**BENICIA CITY COUNCIL  
CONTINUED REGULAR MEETING AGENDA**

**16.A REQUEST FOR CONTINUANCE AND APPEAL OF THE PLANNING COMMISSION'S DECISION TO NOT CERTIFY THE FINAL ENVIRONMENTAL IMPACT REPORT (FEIR) AND TO DENY THE USE PERMIT FOR THE VALERO CRUDE BY RAIL PROJECT**

**SUBJECT** : **REQUEST FOR CONTINUANCE AND APPEAL OF THE PLANNING COMMISSION'S DECISION TO NOT CERTIFY THE FINAL ENVIRONMENTAL IMPACT REPORT (FEIR) AND TO DENY THE USE PERMIT FOR THE VALERO CRUDE BY RAIL PROJECT**

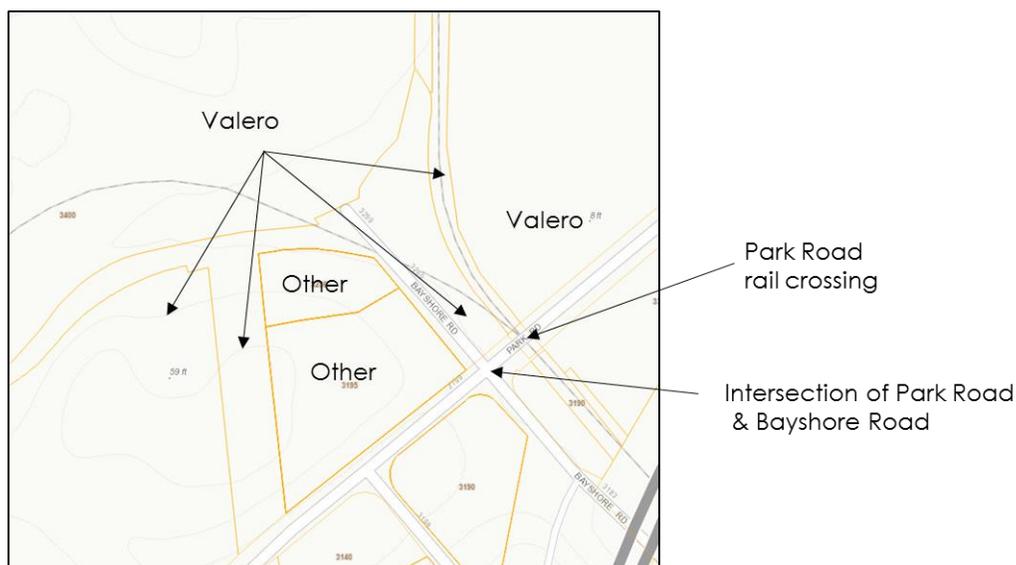
Question 6. Is the Park Road crossing close enough to the Valero property line that a train on Valero property would trigger the crossing arms to move? If so, where? (TC)

Response: A response to this question was requested of Valero. Valero has indicated that they are working to provide an answer before the April 18<sup>th</sup> City Council meeting. The diagram below provides property ownership information for reference.

**Figure 1 – Distribution of Hazards and Population Densities**

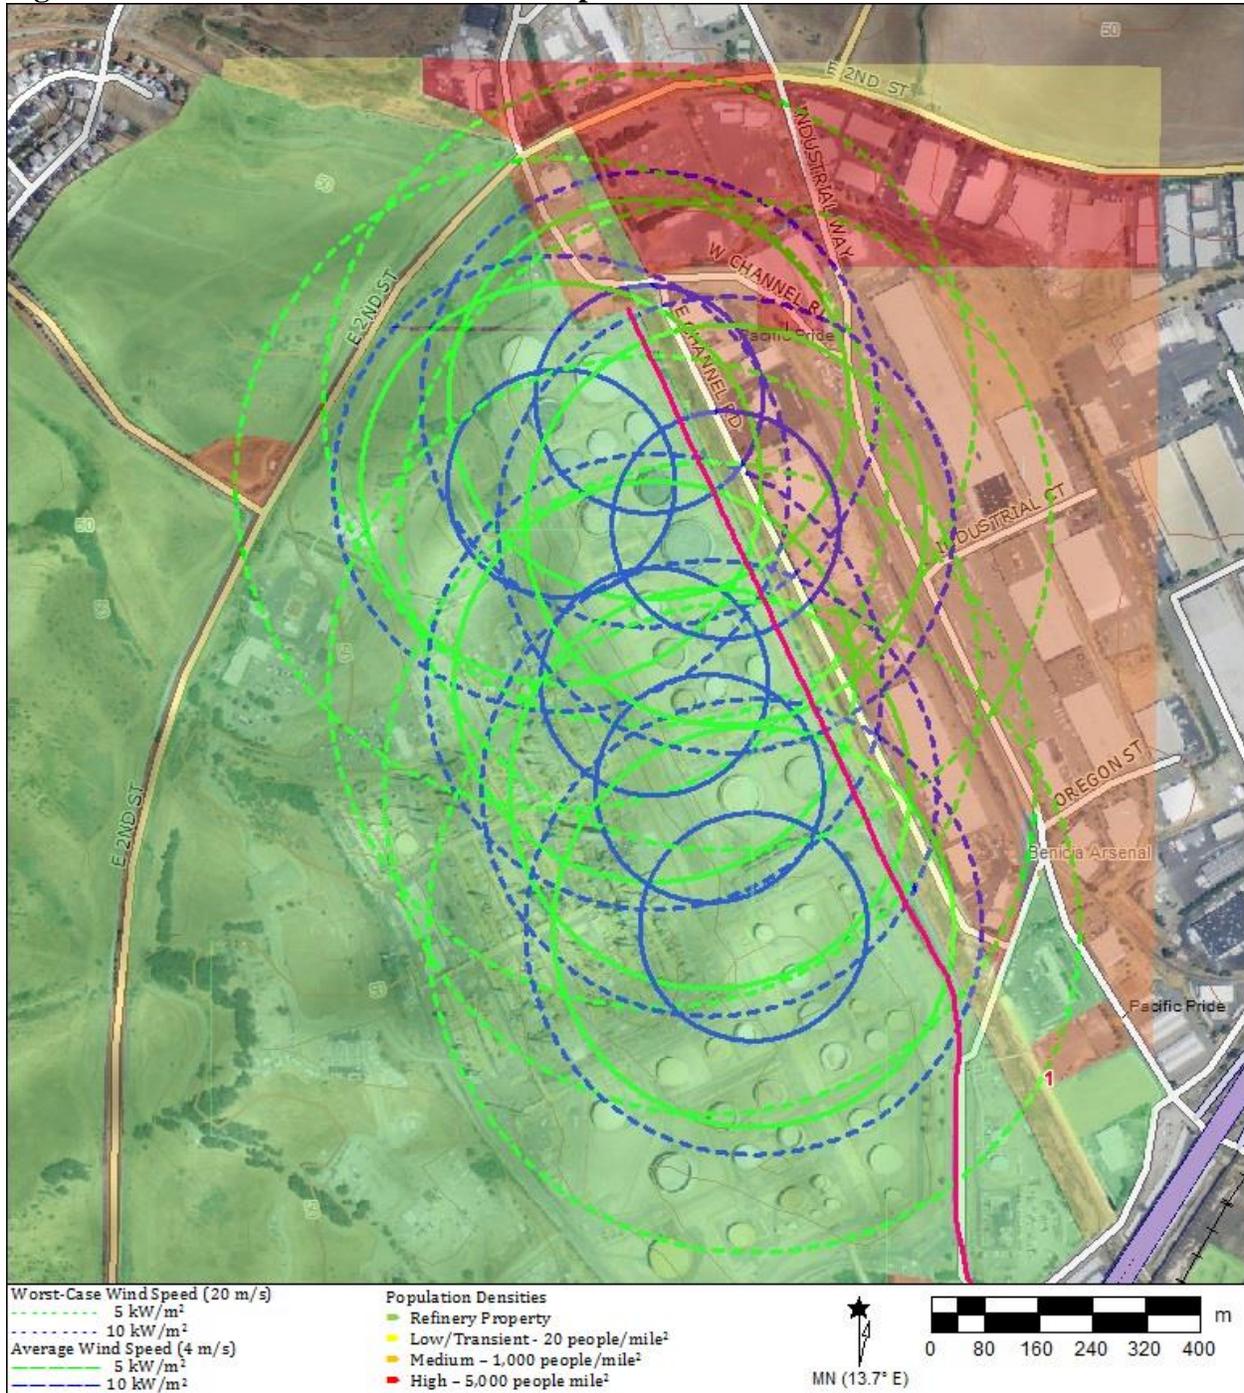
Dr. Fox also comments on the location of a potential hazard zone that was depicted in the EIR showing thermal hazard zones. This is a little disingenuous since Dr. Fox was also provided with a map showing release points and hazard zones for other locations at the unloading facility where a worst-case spill could occur (see Figure 1). The comment points to the end of the rail unloading facility as a point where a worst-case accident could occur and impact offsite populations. However, the facility design would preclude potential worst-case accidents at these points due to the design of the unloading facility drainage system, as well as these locations being well removed from the unloading pumps and operated under suction, which would minimize spill volumes at these locations.

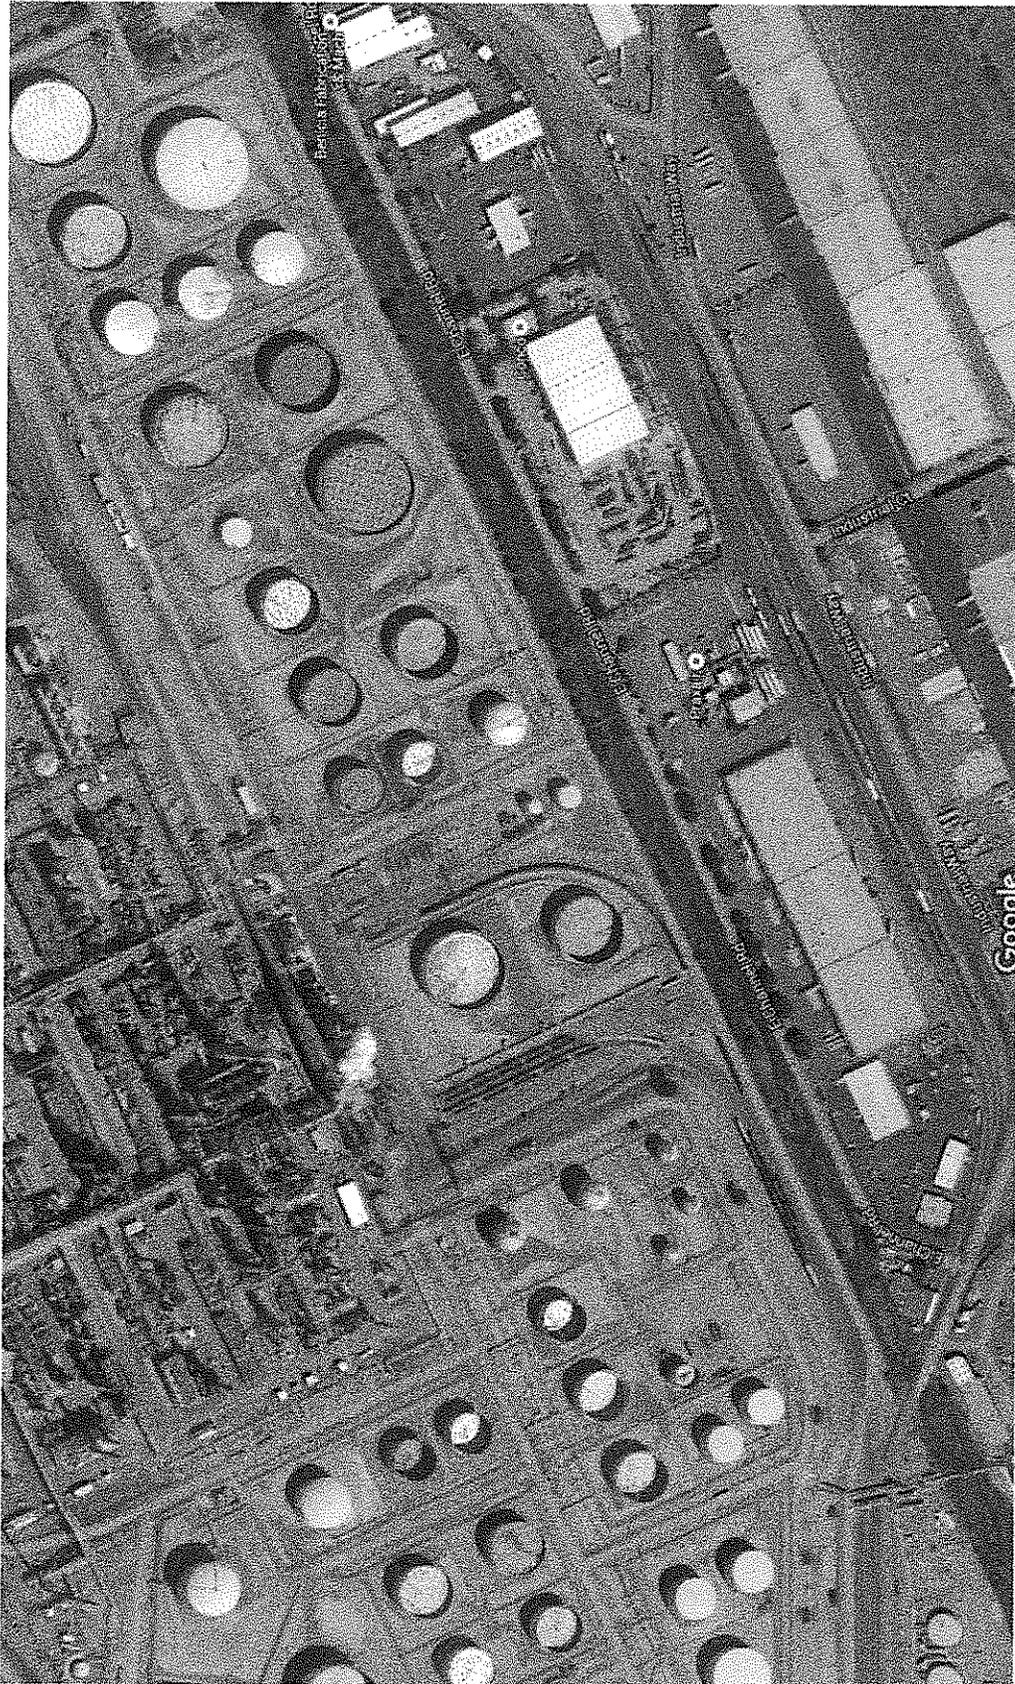
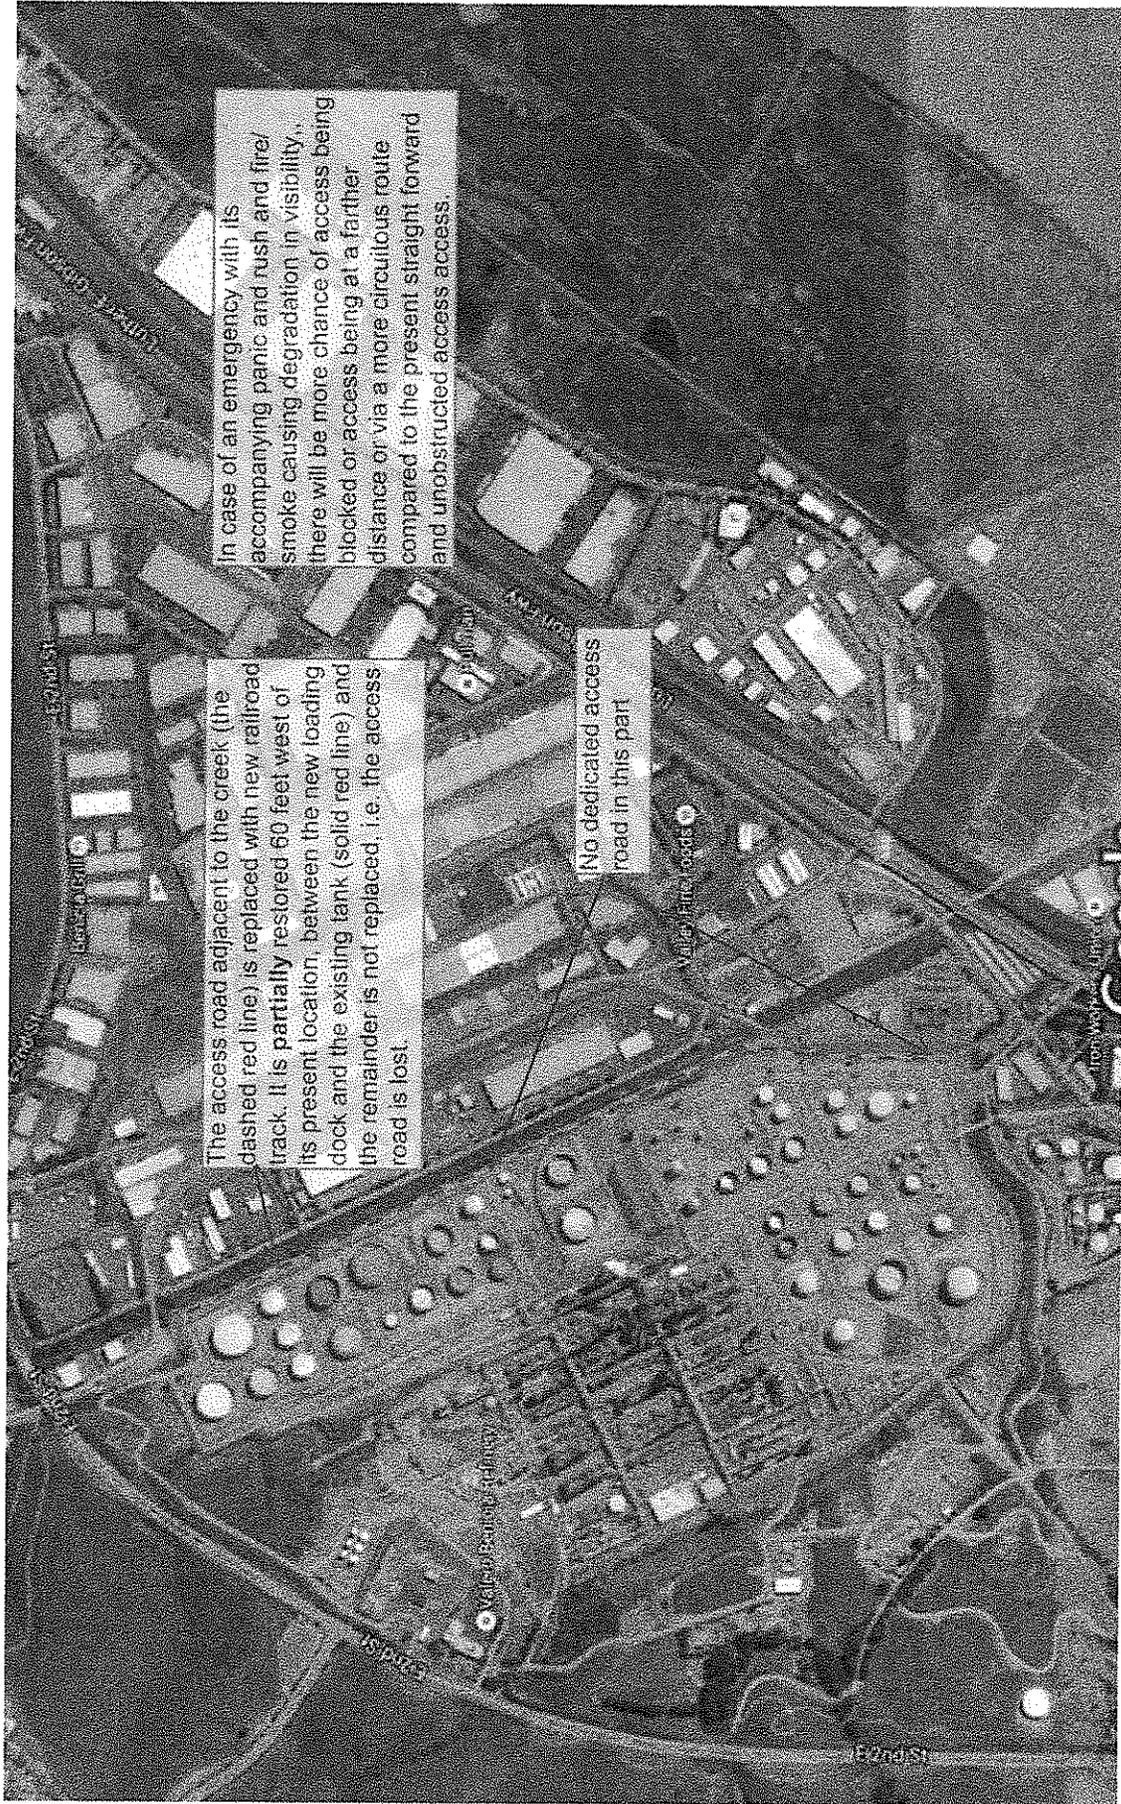
City of Benicia Municipal Code's section regarding the setback is very brief. This might cause ambiguity for some as to what really constitutes a "development", and what is the meaning of "top of the bank"? That is why I have enclosed at the end of this letter similar provision for the City of Santa Rosa, where "development" is defined in detail, and "top of the bank" geometry is graphically defined in sketches. Please note that roads and walls are defined as development and are prohibited in the setback. Also please note that the top of bank definition requires drawing a 2.5 to 1 line from toe of the stream bank to the ground surface.

We note that there are no retaining walls or barriers at this location on the drawings that we have seen. The latest drawing available (Dwg 89413, revision 01-08-16) in Sections A-A or D-D shows only an 8 inch high curb. Moreover, given the trains size and weight, we do not believe a 3 foot high wall will stop a train from tipping over. (See the attached Section A-A, where we have shown a 3 foot high wall and it is apparent even to non-engineers that this not a serious solution to prevent train tip over.

Response: The figure presented in the EIR was excerpted from a discussion level plan submitted with application materials. According to the stamp on the drawing, it clearly was not intended to provide construction level detail. Under normal practice, detailed construction drawings would be prepared if and only if a project is approved because they must reflect all conditions of approval, including any mitigation measures and all other requirements required by the lead agency and other permitting agencies.

BMC Section 17.70.340 would govern construction of the Project regardless of whether the City took the “belt and suspenders” approach of requiring compliance with the provision as a condition of permit approval. The construction plans submitted for building permit will provide the necessary level of detail to confirm the 25-foot setback is met and will be reviewed for compliance with this requirement. In addition, the setback would be verified in the field by a licensed surveyor. Valero is aware of this requirement.
